President Millman and Honorable
Commissioners
City Planning Commission
200 North Spring Street
Los Angeles, California 90012

Re: Venice Auxiliary Pump Plant (VAPP), 128 and 133 Hurricane;
DIR-2017-4167; ZA-2017-3950 (plant); DIR-2017-4173; ZA-2017-3953 (parking lot)

This letter is submitted on behalf of the appellants, Michael and Genevieve Morrill-Borassi, as well as other neighbors who will be impacted by the proposed Public Works project at 128 and 133 Hurricane on the Marina Peninsula.

Venice Auxiliary Pump Plan Project Site

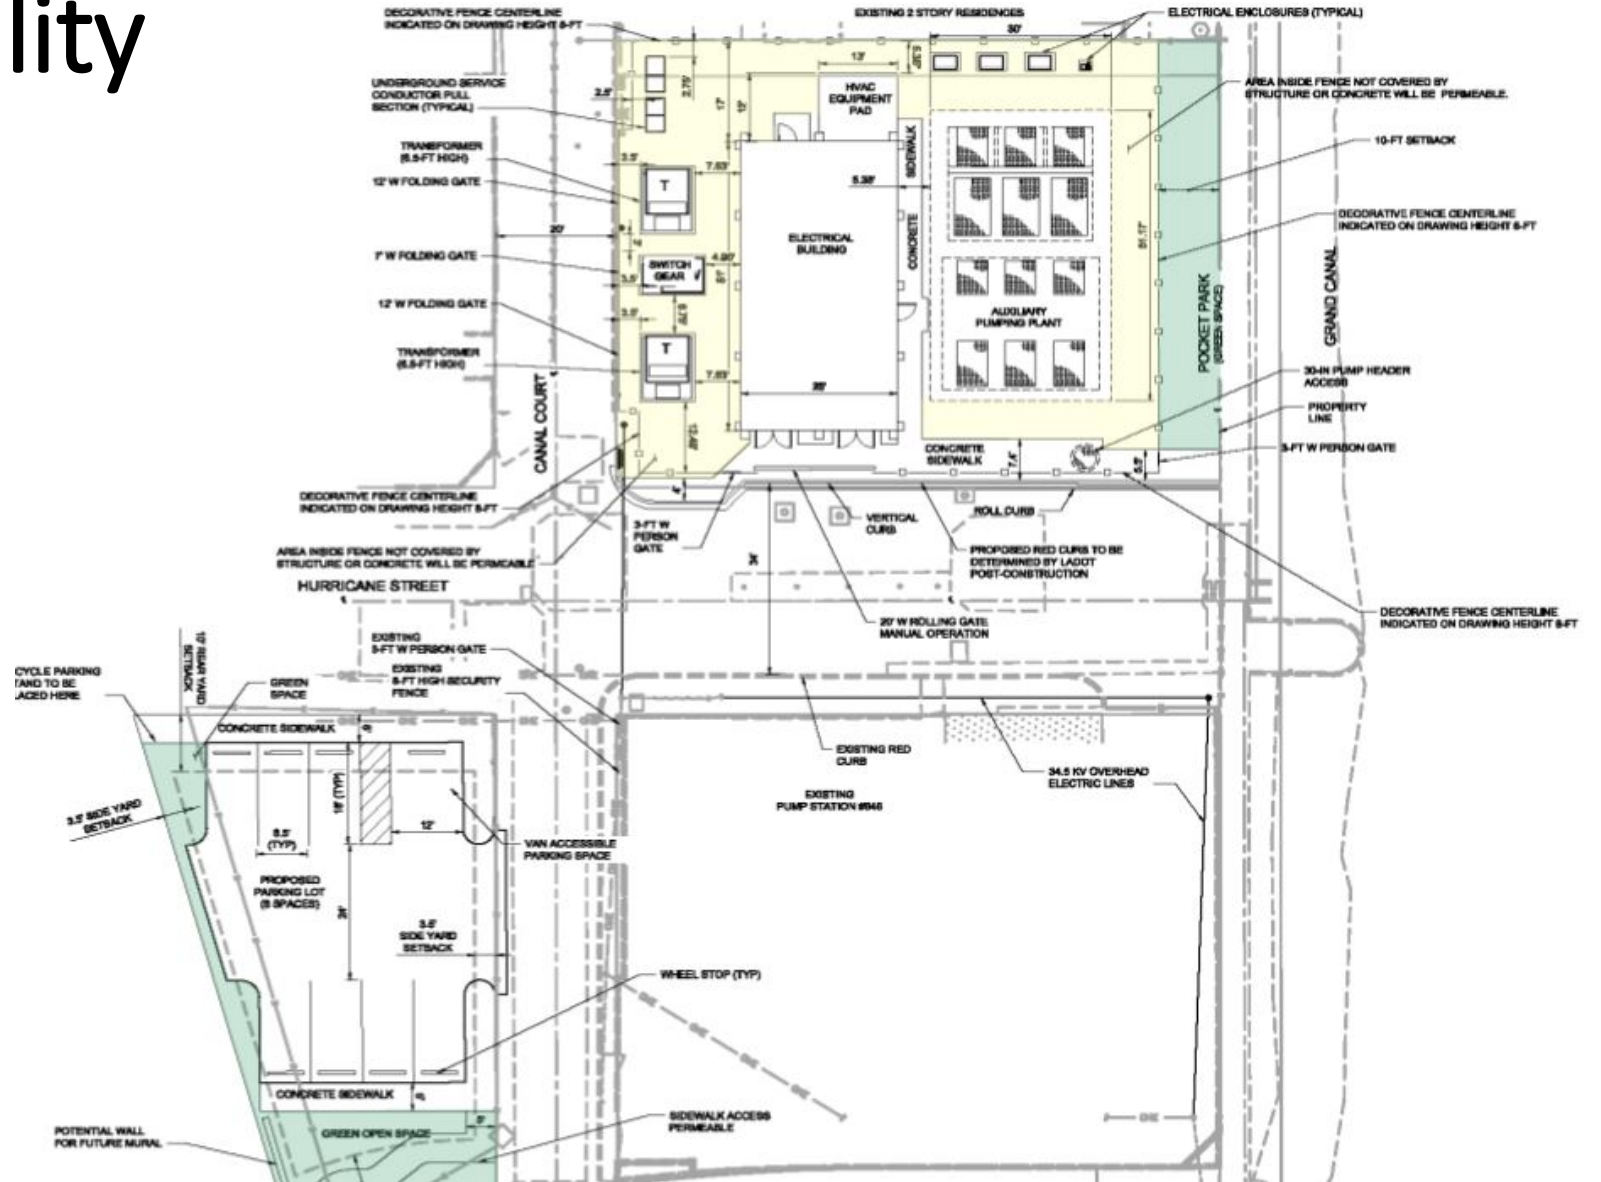
- The EIR for the project and prior presentations misrepresented the location of the project, which is in fact 10 -15 feet closer to the nearest residential structure than previously represented.

- The project is poorly designed to fit within its residentially zoned neighborhood. Noisy and dangerous equipment is located very close to two neighboring residential areas. However, on the other side, the project site is adjacent to a dead-end street and the exiting pump plant, and all noisy and dangerous equipment should be located nearer to this facility and away from residents.

In the cases before you, Public Works has been granted a series of special adjustments and “alternative” compliance measures that don’t make sense in this case. While most of the project site adjoins open space, a City facility and streets, the equipment for this facility has been jammed up against the nearest residential uses, with transformers less than four feet from bedroom windows. A more thoughtful design that really fits into this location needs to be proposed.

- The new facility must be designed and landscaped in keeping with the residential area and sensitive lagoon.
- Provide a buffer of landscaping and walls between the new facilities and the directly adjacent residential buildings, including a minimum 6-foot block wall and 10 feet of landscaping between both the parking lot and the new facility and the nearest adjoining residential property to the north and west.
